### David Sorenson 7592 Potami Road Side Lake MN

## Request

- To allow an accessory structure 8 feet from the right-ofway where 10 feet is required.
- To allow a garage that will exceed the 15% overall building footprint of a non-conforming parcel. The applicant is proposing 19%.

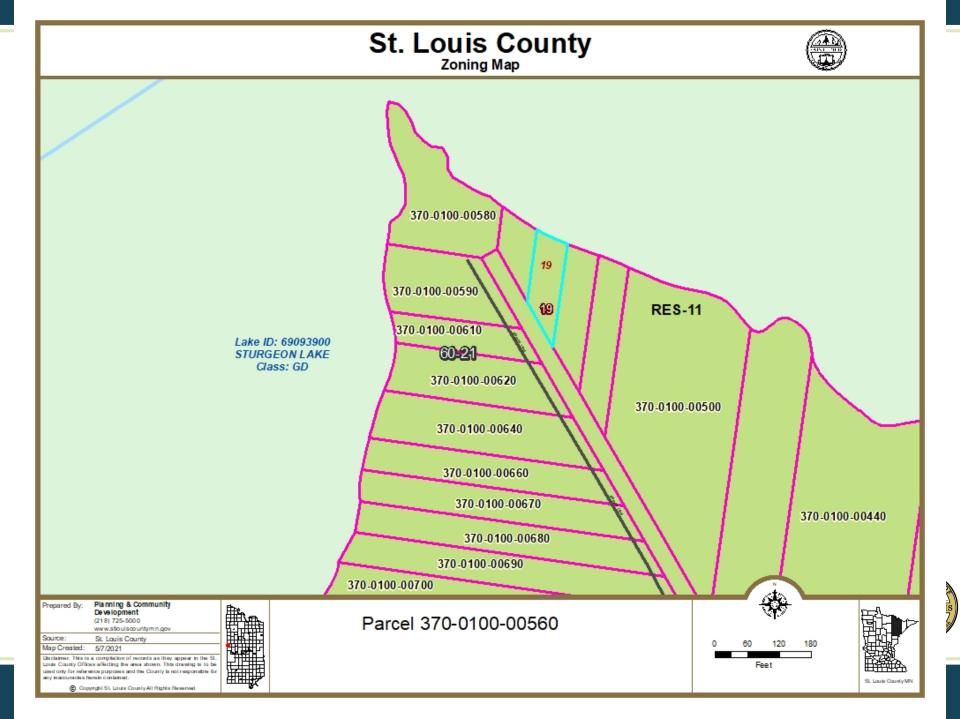
- 1. Zoning Ordinance 62 states that Riparian lots that do not conform to the minimum area standards are allowed a maximum building footprint of 15 percent of lot area. The applicant is requesting 19%.
- 2. Zoning Ordinance 62 states the required setback from a right of way is 10 feet. The applicant is requesting 8 feet.
- 3. Objective LU-3.1 of the St. Louis County Comprehensive Land Use Plan is to base variance decisions on uniform approval criterion to ensure all applications are treated equitably, that community health and safety is protected, and that the overall character of a given area is preserved.
- 4. Objective LU-3.3 the St. Louis County Comprehensive Land Use Plan is to acknowledge why nonconformities are a concern and that variances should be for exceptional circumstances as noted in Minnesota Statute 394.22. Subd.10.

- 1. The total impervious area shall be reduced by 693 sq. ft. as proposed by the applicant.
- 2. Stormwater runoff from the proposed structure shall not directly discharge on adjacent lots.
